Seneca Army Depot Activity
Romulus, NY

Ordnance and Explosives
Engineering Evaluation
Cost Analysis Report

SUBJECT: Submittal of the Final Ordnance and Explosive Engineering Evaluation / Cost Analysis Report, Seneca Army Depot, Romulus, Seneca County, New York.

This Final OE EE/CA includes revisions in response to EPA comments dated February 21, 2003. The response to comments was previously submitted.

DESIGNED BY JEB	Figure 2.2 Seneca Army Depot Activity Areas of Interest		PROJECT NUMBER: 736703-01000
DRAWN BY JEB			SCALE: 1:50000
CHECKED BY BJM	DATE JAN 2004	PAGE NUMBER	Figure 2.2
SUBMITTED BY SAS	FILE DEPOT.APR

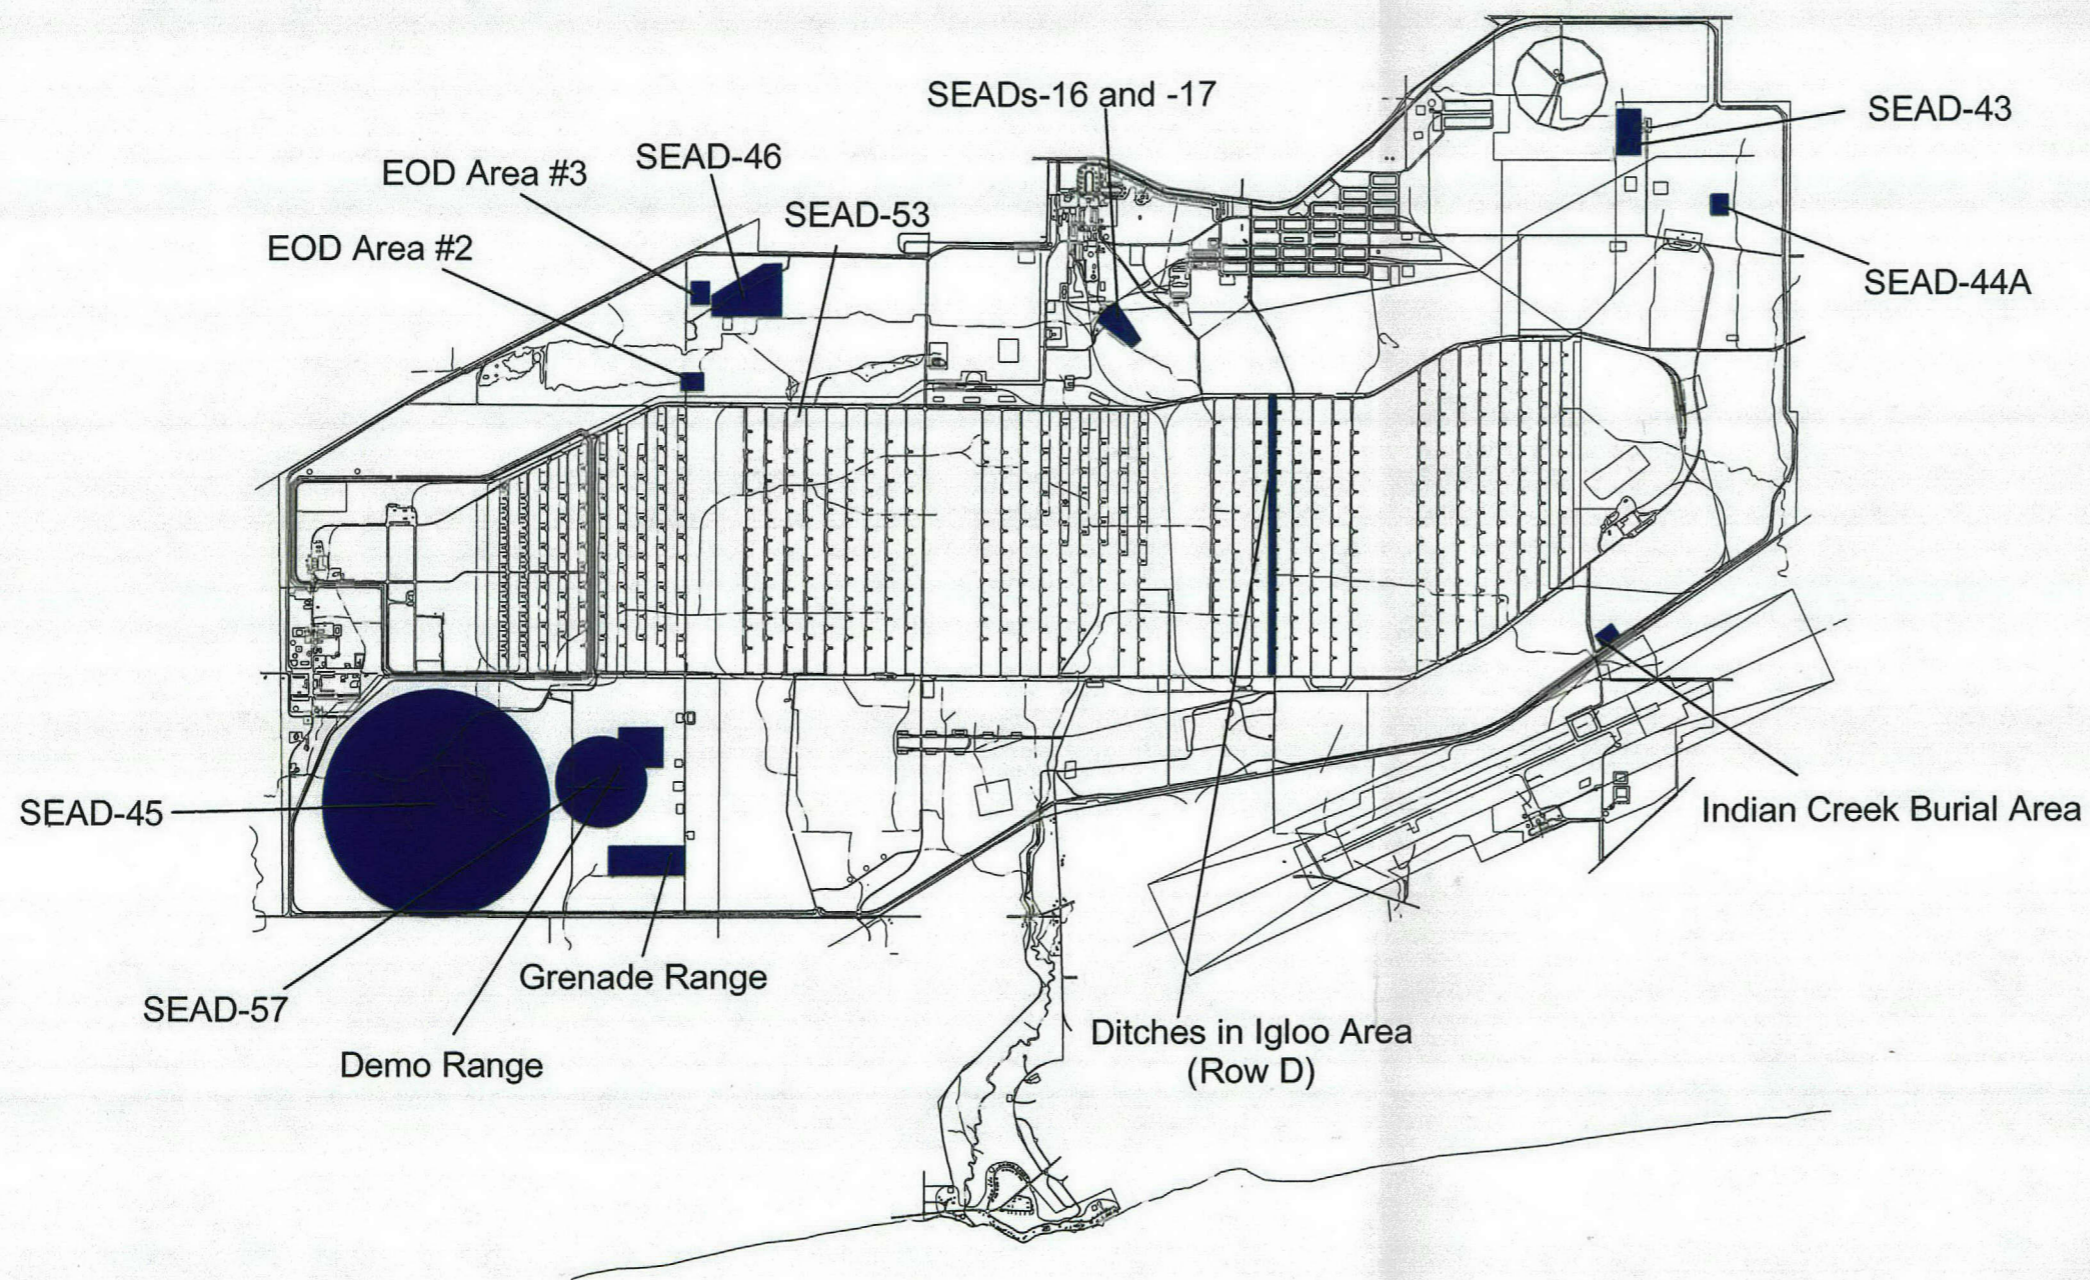
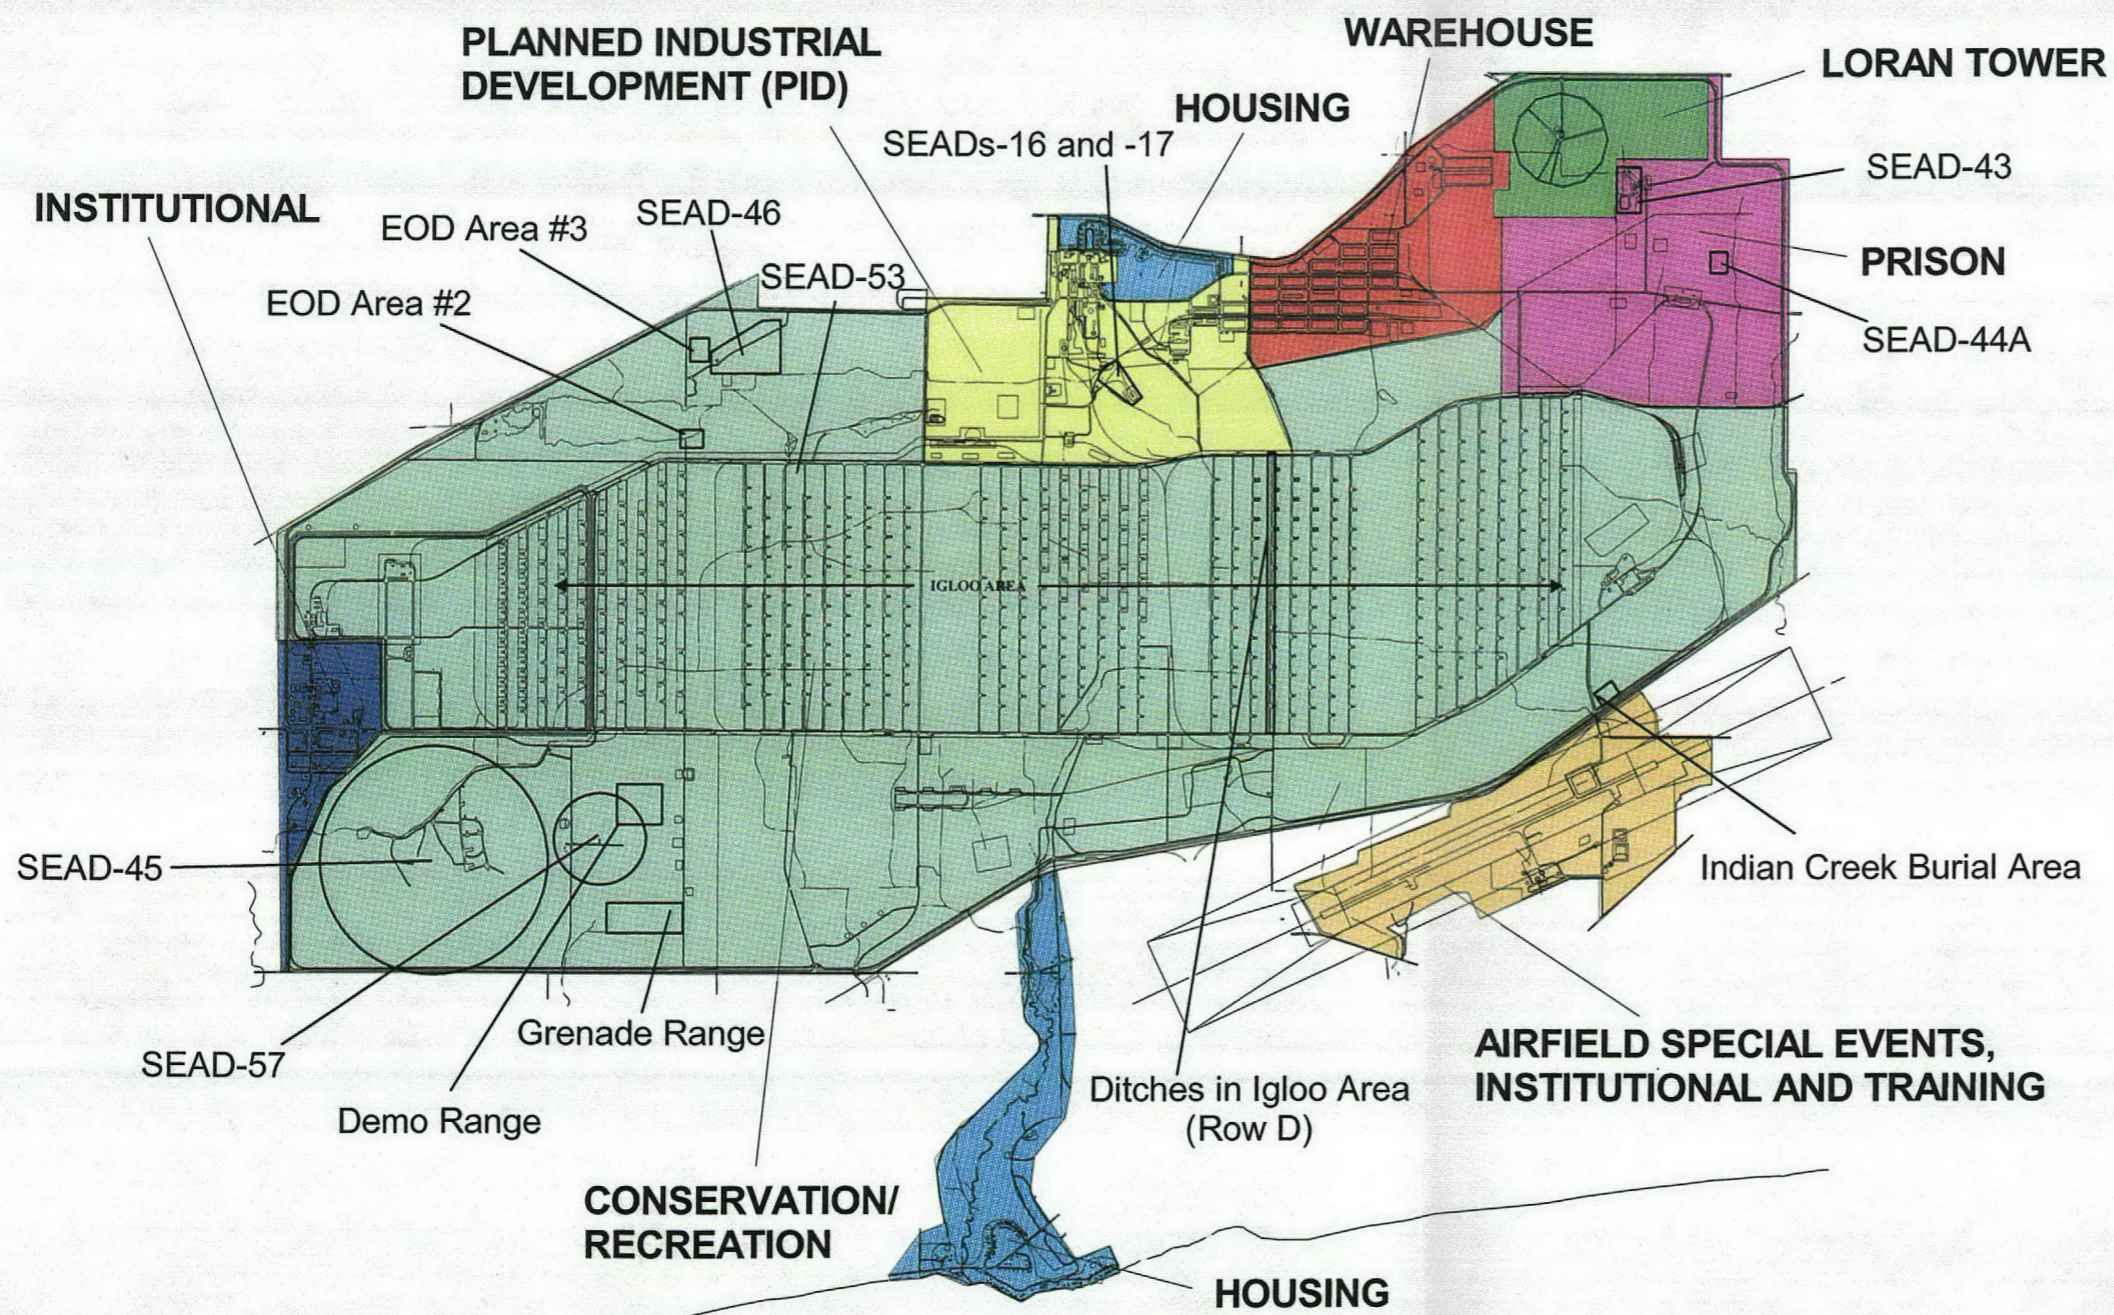
5.	General	Check the north arrows on all maps. They are pointing in the wrong direction on figures 2.2 and 2.3. Correct the arrows on these figures and verify that all others are correct.	A: The north arrows are now pointed north

2.	Figure 2.2 & 2.3	According to Figure 2.1, the North Arrows on Figure 2.2 and 2.3 are not correct. I have not been to Seneca, but just comparing Figures, one or more of these is incorrect.	A: The north arrows are now pointed north.

3.	Figure 2.2	Shade the polygons that make up each of the AOI. It is difficult to tell the boundaries of areas such as SEAD-53, Ditches in Igloo Area (Row D) and SEADs 16 & 17. Similar to the shading in Figure 2.3.	A: The polygons have been shaded, and a polygon has been added for the D Row in the Igloo area.

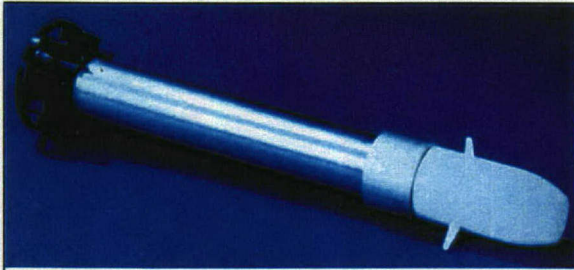
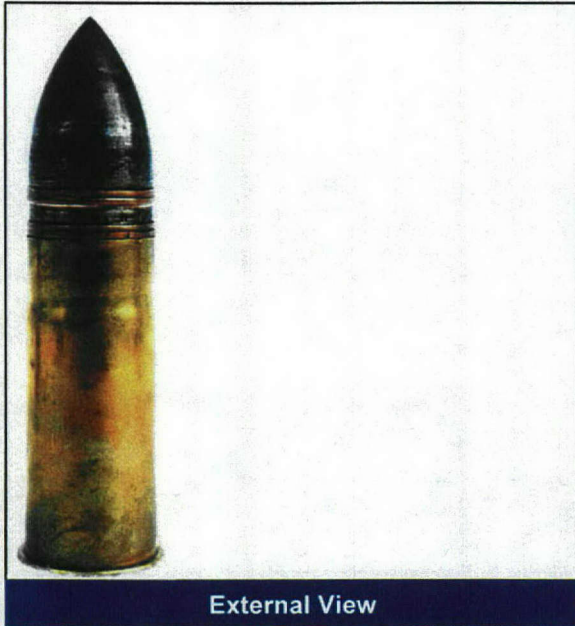
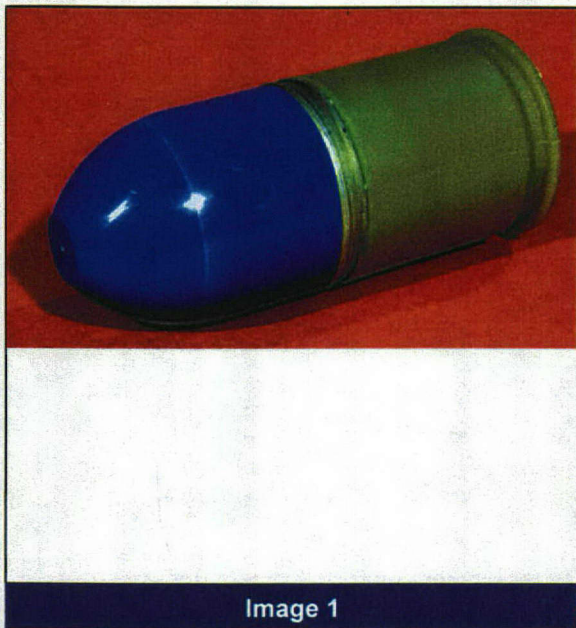
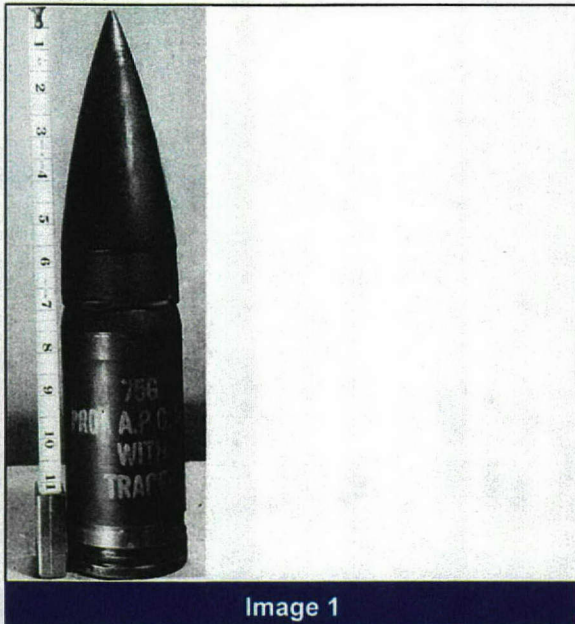
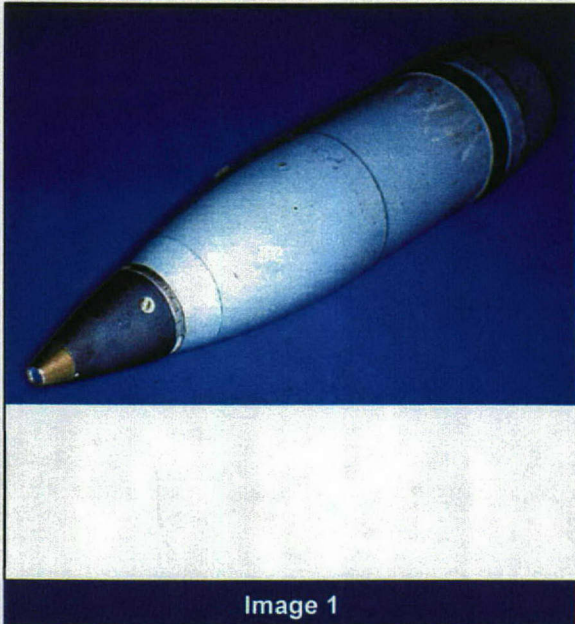
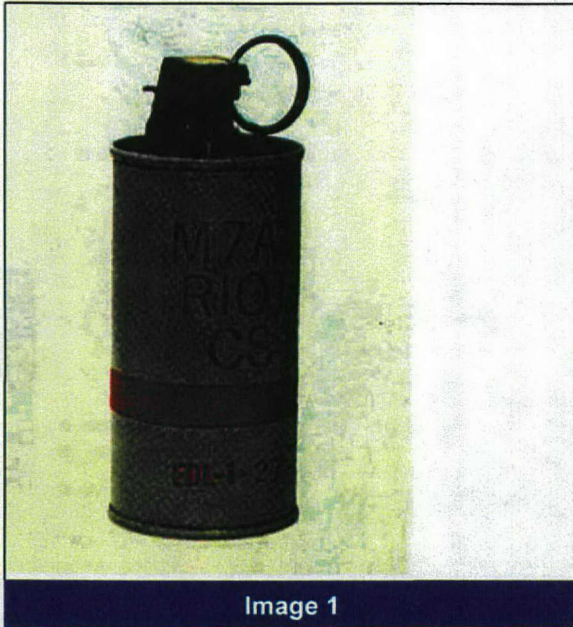
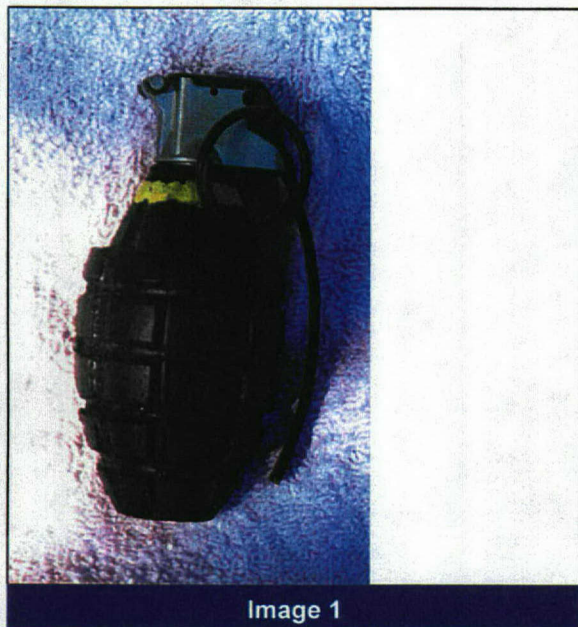
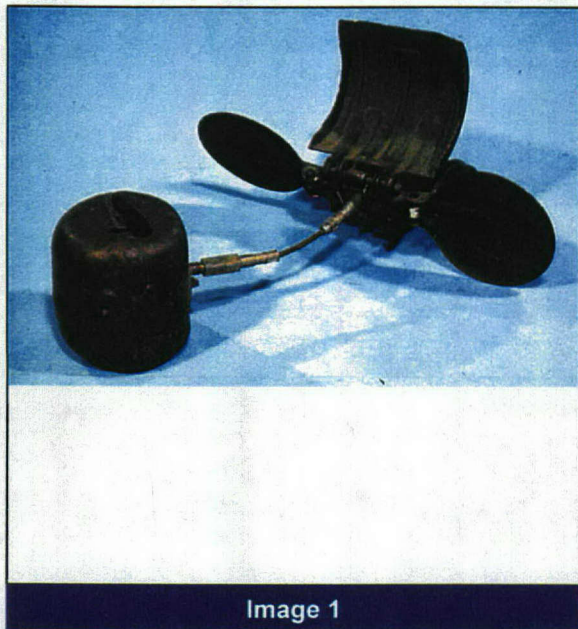
10.	Section 3.9.10	1 st paragraph, 2 nd sentence - Remove "to" in the statement "This data was collected to between ..."	A: The "to" has been removed.
11.	Figures 3.1 - 3.9	Put figure numbers and titles on these figures.	A: Numbers and titles have been added.
